SUBJECT: Forwards info re potential for steam generator water hammer  
 at PWRs w/ feedrings that discharge from bottom, in response  
 to NRC 790918 request.

H. B. ROBINSON STEAM ELECTRIC PLANT, UNIT NO. 2

RESPONSE TO REQUEST FOR INFORMATION - STEAM GENERATOR WATER HAMMER

ATTACHMENT 1

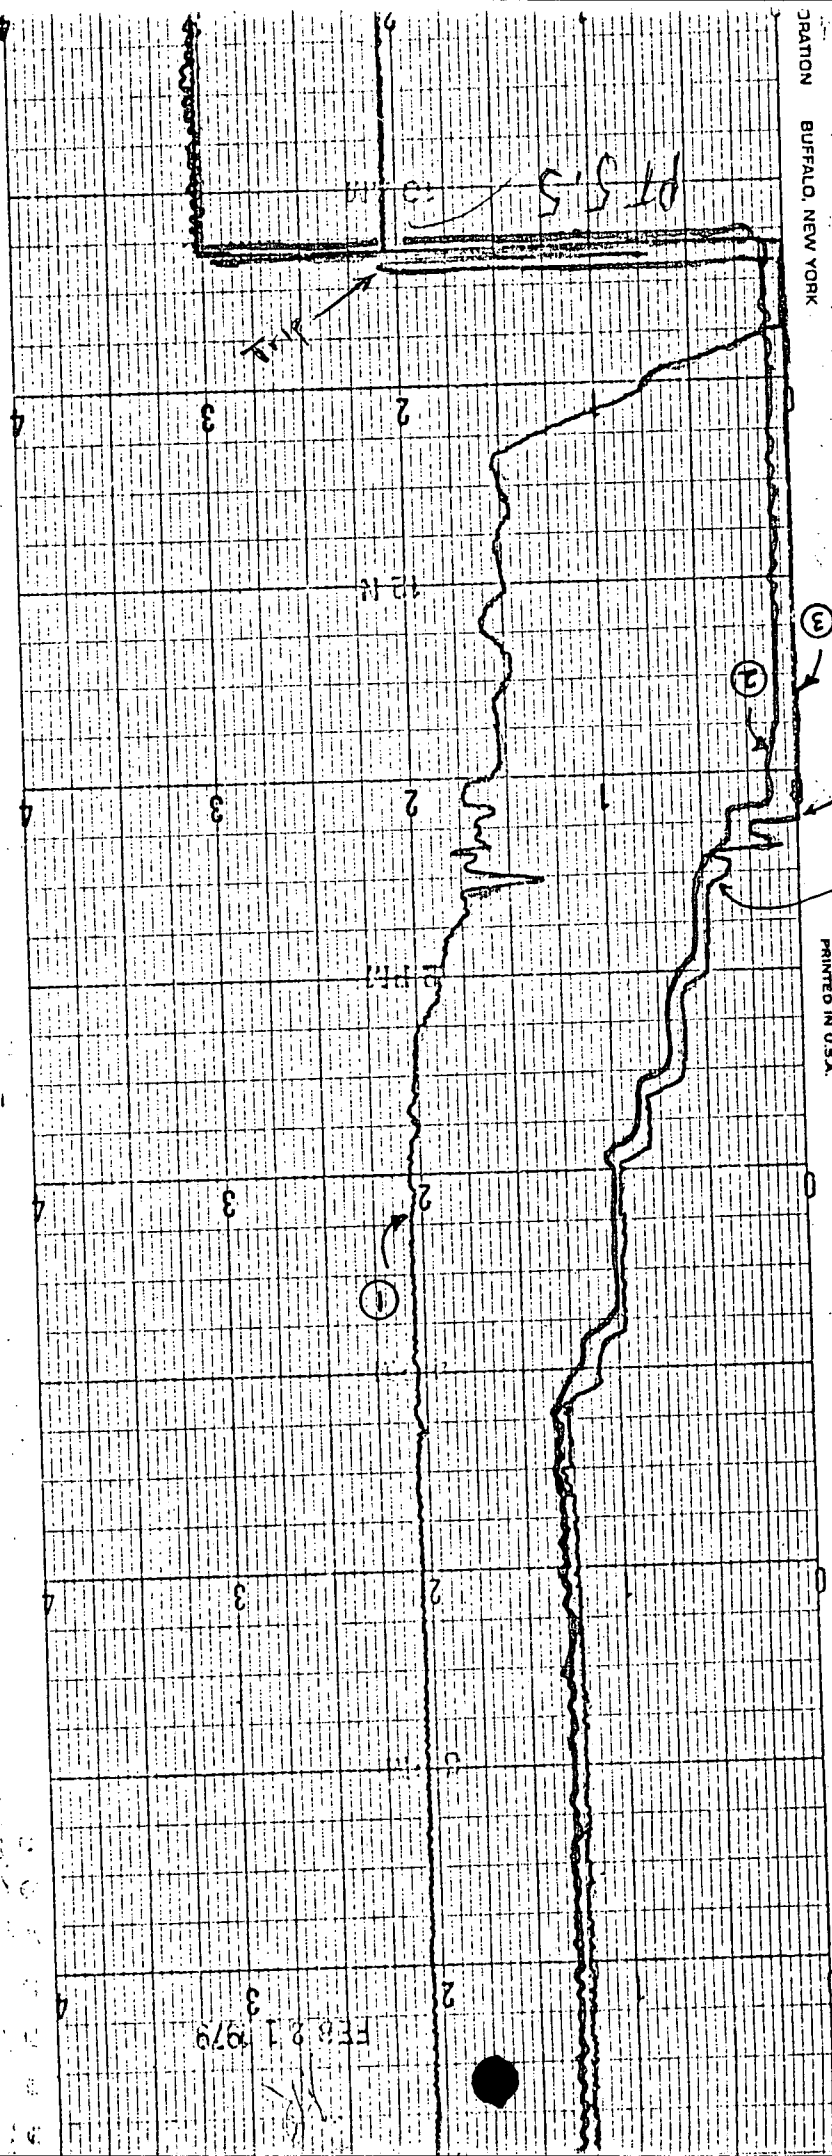
Describe the expected behavior of steam generator water level as a result of reactor trip from power levels greater than 30% of full power. Include actual plant measurements of steam generator level and other available related data such as feedwater flow and auxiliary feedwater flow.

See Attachments 1, 2 and 3.

# TRIP FROM 100% R<sub>s</sub> Power at 1029 on 2-21-79
